LINCOLN-LANCASTER COUNTY HEALTH DEPARTMENT

Soil Absorption Test Data Report
Annex to Application

Address 5408 Saltillo (no rural route) City Roca NE, Zip

Leibel Addition—06071-File Notes D.S 6/5/07

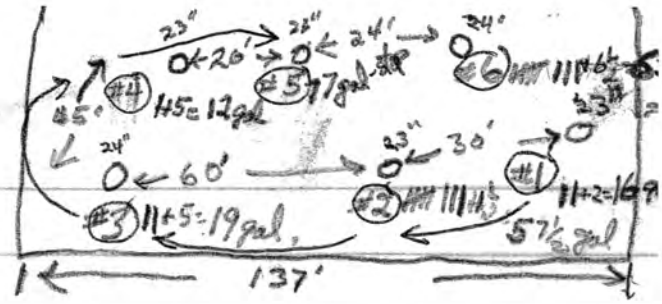
* Recommend an engineered designed onsite system for this lot.

Remarks 1/4"+ cracks in soil of perc test area. Soil powder dry at bottom of hole when boring except #3 which was slightly moist. Because of drought condition + large cracks in soil, several 24 hr. continuous presoak would be needed to adequately presoak this perc test area.

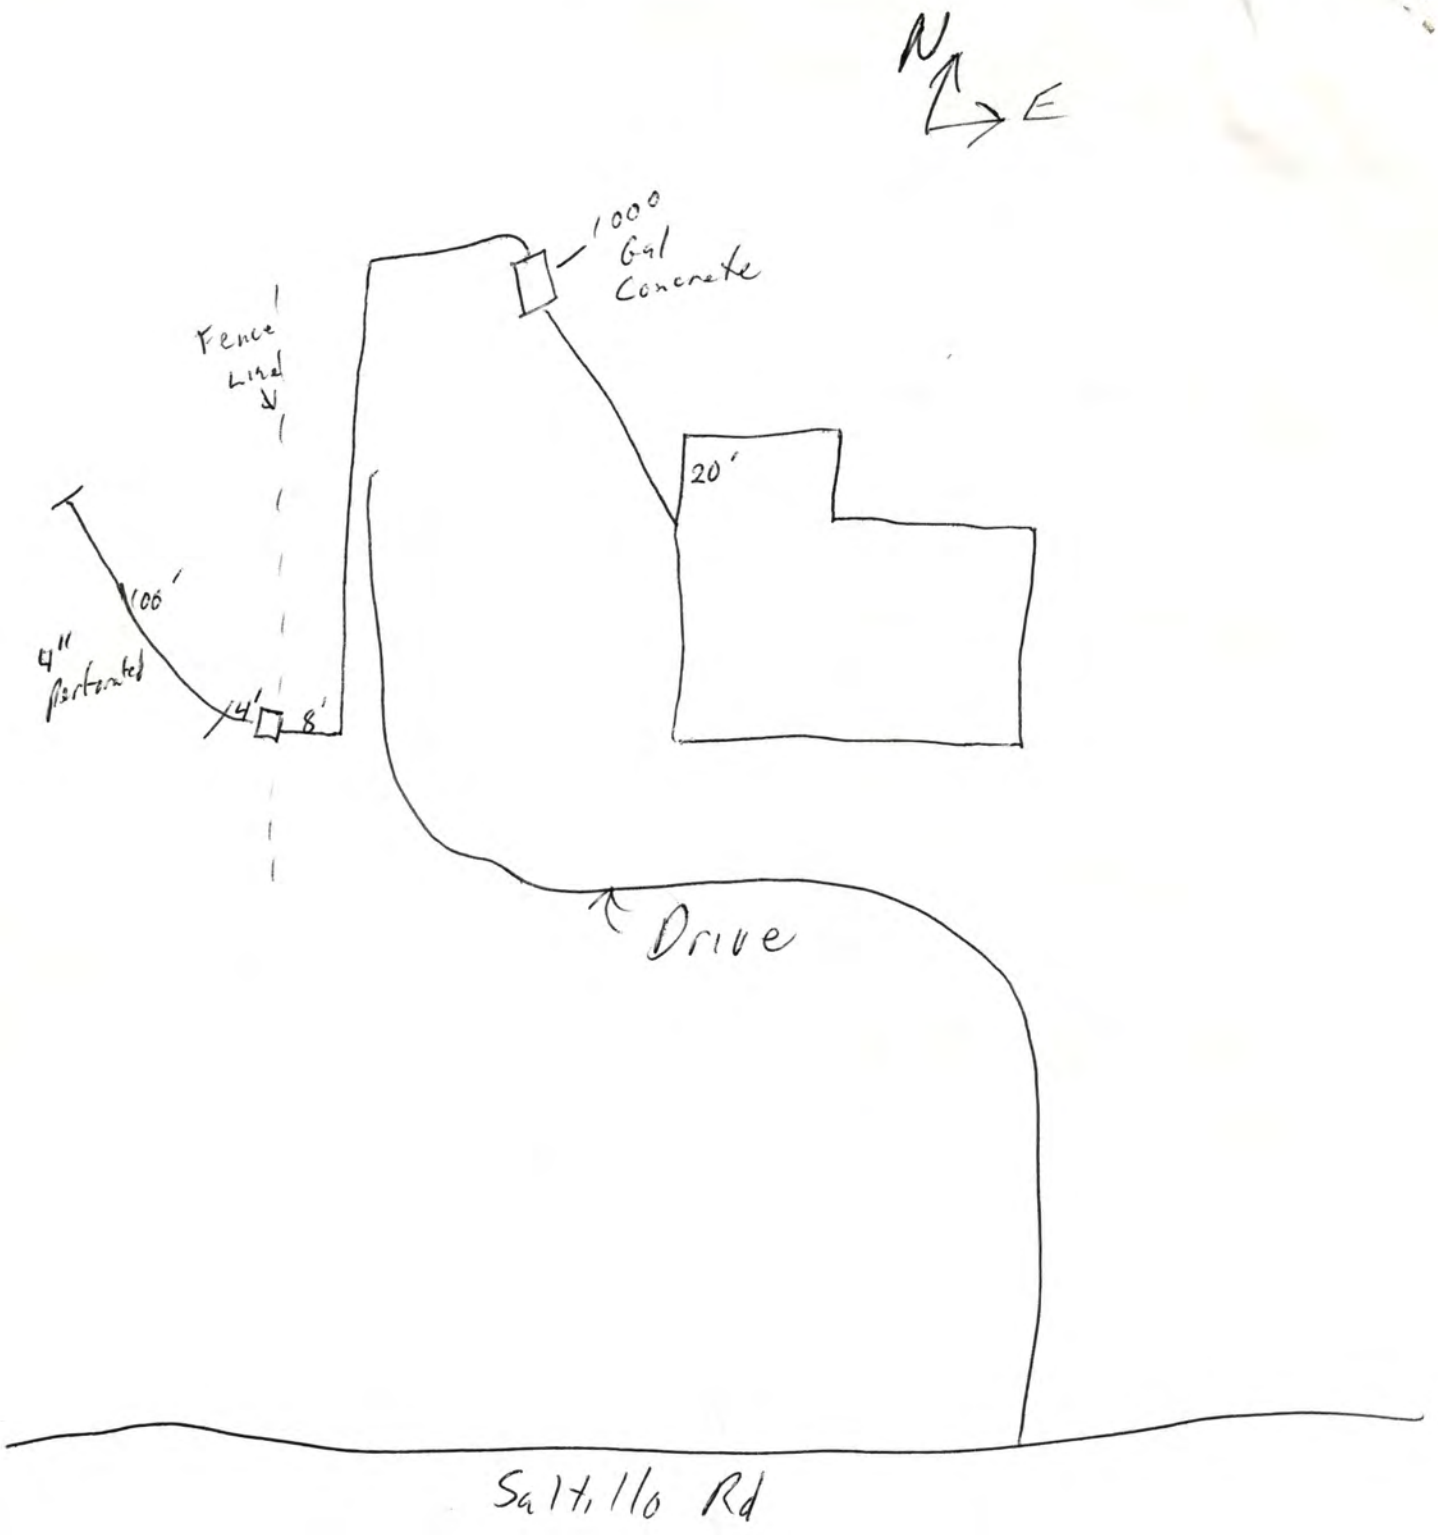
Remarks Appears to be only about 24" of passing perc test soil above Pawnee Clay loam soil, this is not satisfactory for a standard absorption field of a septic system. This test does not appear to have had an adequate presoak.
